CODE CHANGE PROPOSAL FORM

Model Code: ANSI A117.1

Intended for Technical Advisory Group ("TAG"): 1341

MN Rule 1341.0604 Subpart 1 Section 604.3.2.2 water closet clearance.

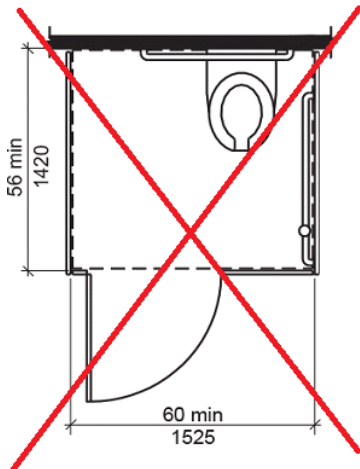
604.3.2.2 Water closet clearance. The depth of the clearance around the water closet shall be ~~48~~ 52 inches (1220 mm) minimum plus the depth of the water closet fixture.

(Note: will need to modify the MN Figure 604.3 to show the 52” depth in front of toilet)

~~FIGURE 604.9.2(A)~~

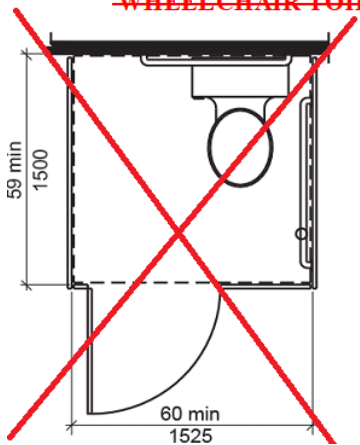
Wheelchair accessible toilet compartments shall comply with Section ~~604.9.2.1, 604.9.2.2~~ 604.3 where the compartment door swings out or 604.9.2. ~~13 as applicable.~~ where the compartment door swings in.

~~WHEELCHAIR TOILET COMPARTMENTS WALL HUNG CLOSET, ADULT~~

~~FIGURE 604.9.2(B)~~

~~WHEELCHAIR TOILET COMPARTMENTS FLOOR MOUNTED WATER CLOSET, ADULT - WALL HUNG AND FLOOR MOUNTED WATER CLOSET, CHILDREN~~

1. Why is the proposed code change needed? Please provide a general explanation as well as a specific explanation for any changes to numerical values (heights, area, etc.)
This change will align the new 52" deep wheelchair clear floor space with the depth requirements for toilet clearance and toilet compartment size in Minnesota. It both maintains some Minnesota amendments while also incorporating updated depth requirements from the model code.
2. Why is the proposed code change a reasonable solution?
To align with the new wheelchair clear floor space depth required elsewhere in the code, to maintain consistency throughout the code.
3. What other factors should the TAG consider?
Increased wheelchair clear floor space depth discussed in previous code sections.

FIGURE 604.9.2.3

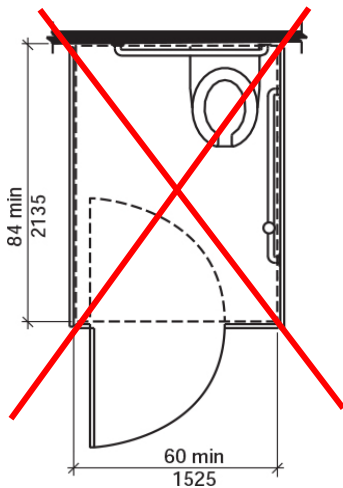
604.9.2.13 Alternate Wheelchair accessible toilet compartments with in-swinging doors.

Where an alternate a wheelchair accessible toilet compartment is provided has an in-swinging door the minimum area of the compartment shall be 60 inches (1525 mm) minimum in width, measured perpendicular to the side wall, and 84 inches (2135 mm) minimum in depth, measured perpendicular to the rear wall.

~~WHEELCHAIR TOILET COMPARTMENTS ALTERNATE WHEELCHAIR TOILET COMPARTMENT~~

FIGURE 604.9.13(B)

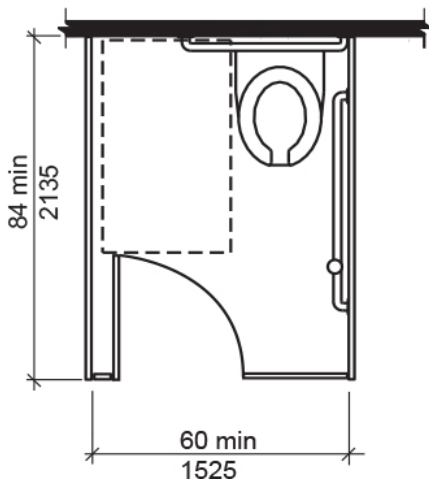
~~WHEELCHAIR TOILET COMPARTMENTS ALTERNATE WHEELCHAIR TOILET COMPARTMENT WITH IN-SWINGING DOOR.~~
